Proposed Revisions to a Standard Plans Index

Index Number: 425-001

Sheet Number (s): 1, 3 and 4 of 8

Index Title: Supplementary Details for Drainage Structures

PIPE TO STRUCTURE ~~FILTER FABRIC WRAP~~

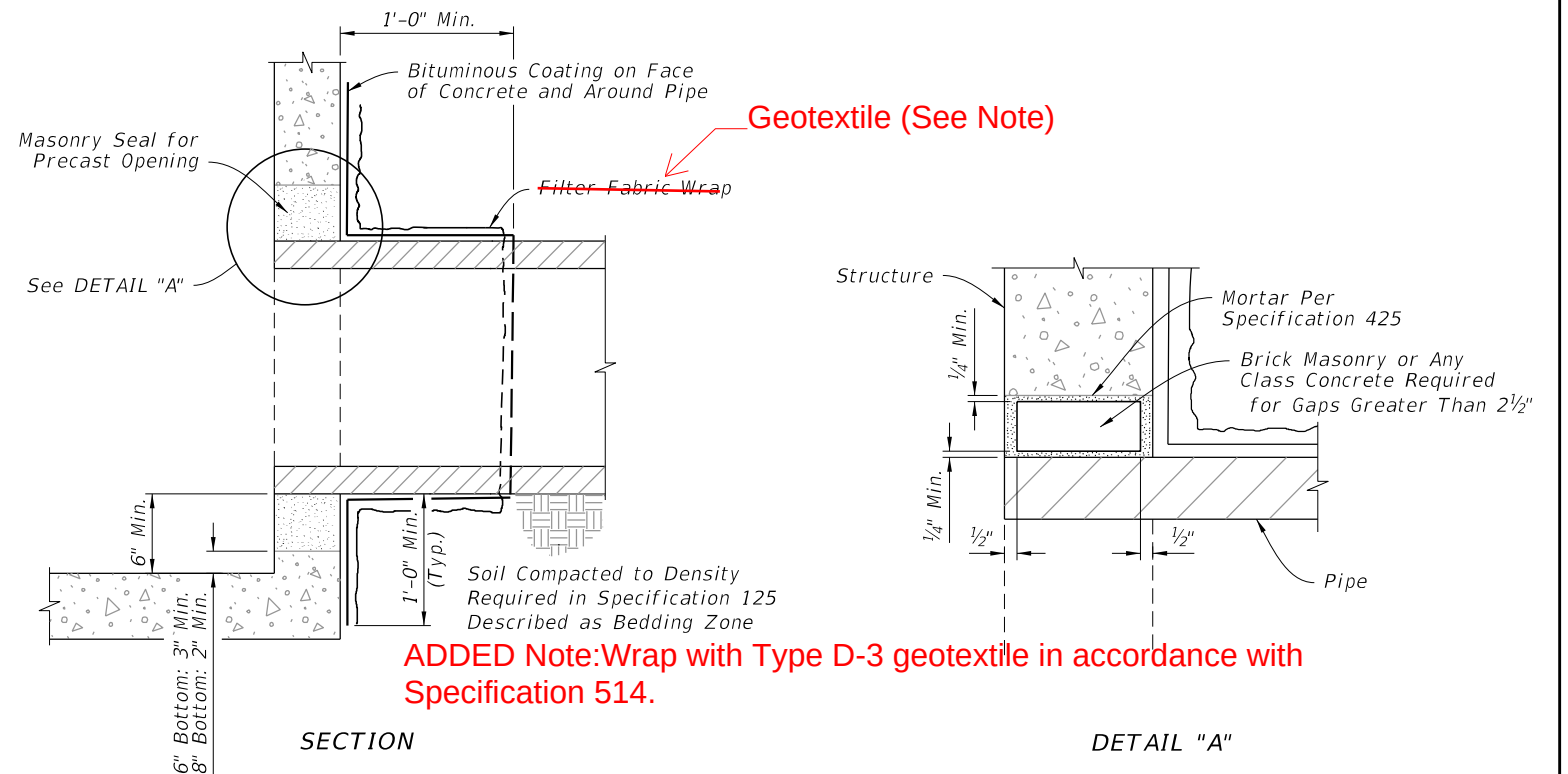
Sheet 3: Added Note "Wrap with geotextile in accordance with Specification 514." to the PIPE TO STRUCTURE FILTER FABRIC WRAP detail; Changed all references of "Filter Fabric" to "Geotextile".

SUMP BOTTOM

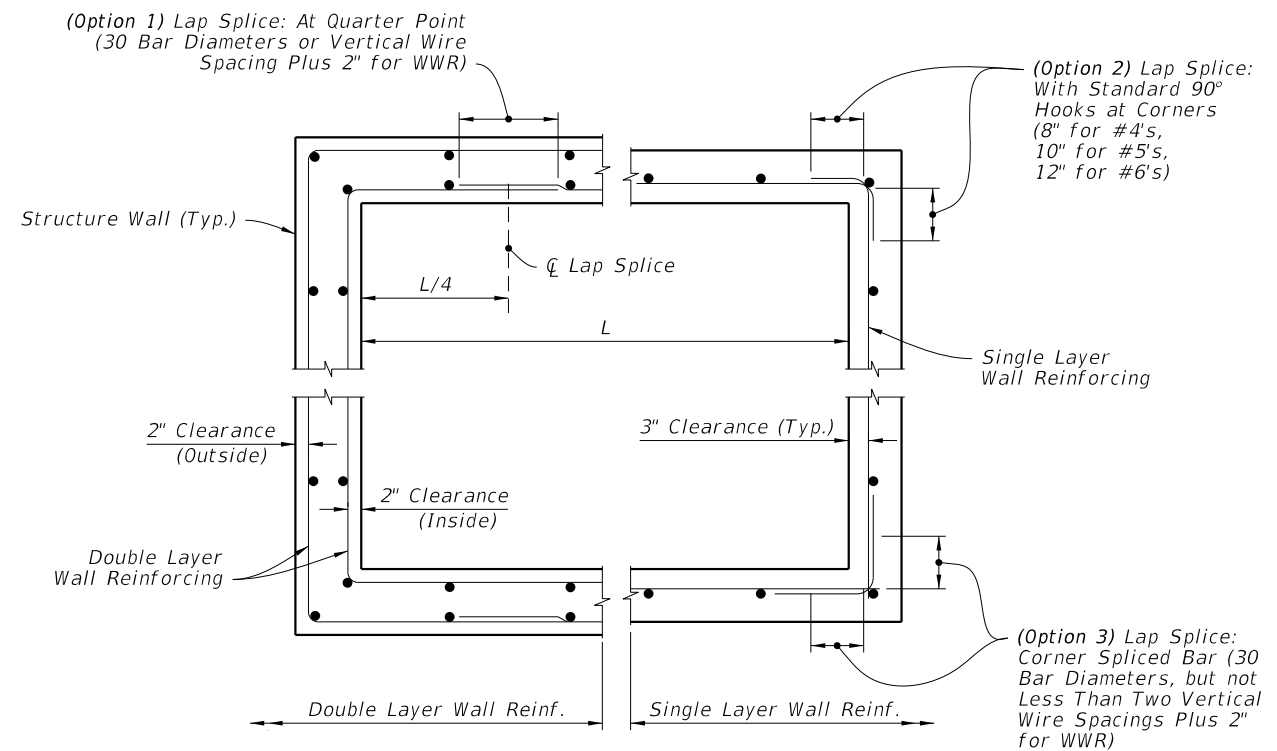
Sheet 4: Added Note 4 "Install Type D-3 geotextile in accordance with Specifications 514." to the SUMP BOTTOM detail.; Changed all references of "Filter Fabric" to "Geotextile".

Note 4: Install Type D-3 geotextile in accordance with Specifications 514.
